## COUNTY OF ERIE

DEPARTMENT OF ENVIRONMENT & PLANNING  
DIVISION OF SEWERAGE MANAGEMENT

January 16, 2026

Re: Draft State Pollutant Discharge Elimination System (SPDES) Permit NY0095401  
Erie County Sewer District (ECSD) No. 3  
Application ID: 9-1448-00012/00004

*Figure 1: 2021-2024 Data for Influent and Effluent Ammonia Concentrations (as NH3)*

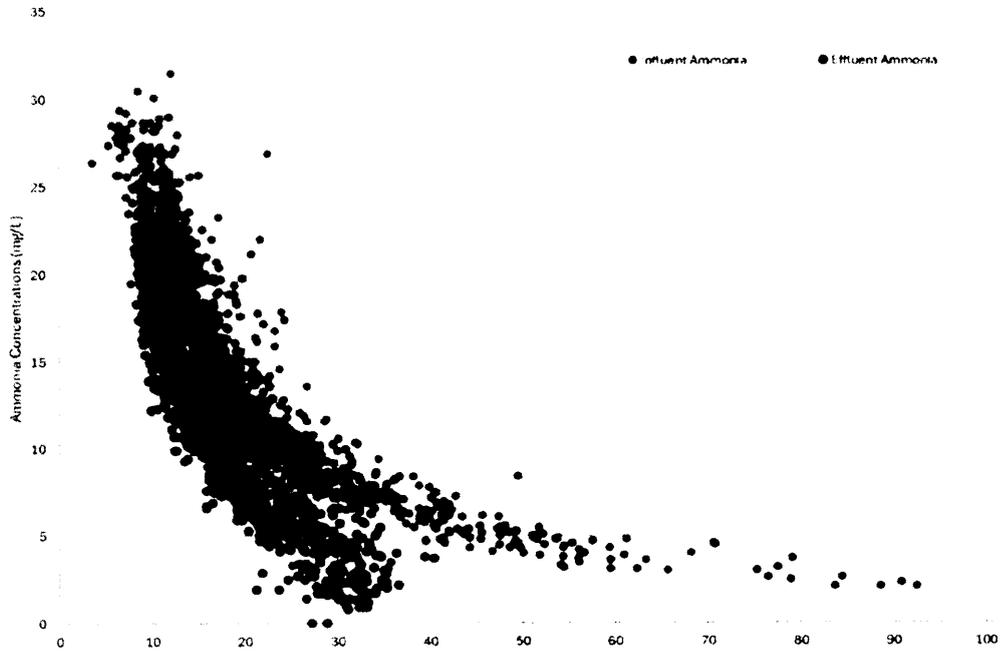
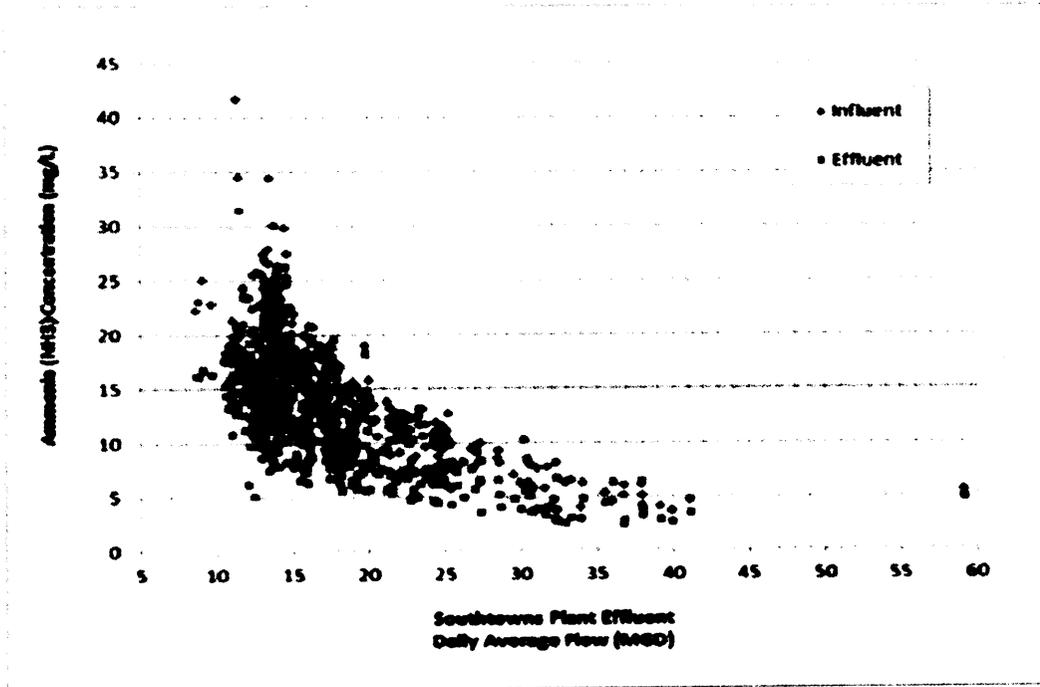
*Key Takeaway #1 – Ammonia concentrations decrease as flows increase, and hence CORMIX modeling is conservative using maximum monthly design flows*

Figure 1 and Figure 2 below present data for influent and effluent ammonia concentrations. These data demonstrate that effluent concentrations decrease as flows increase, in part due to the influences of infiltration/inflow. This is because infiltration/inflow has lower pollutant loadings than sewage.

Both the CORMIX modeling analysis completed by the NYSDEC, as well as the CORMIX modeling completed for the July 2025 memorandum, consider the maximum monthly flow rates to determine the DFs. Table 2 demonstrates that as flows decrease, the associated DF increases. When compared to the corresponding effect regarding effluent concentrations and flows, these CORMIX modeling evaluations are conservative in nature. In other terms, when the concentrations are the highest, so too are the DFs; but the SPDES permit limitation is static using a lower DF.
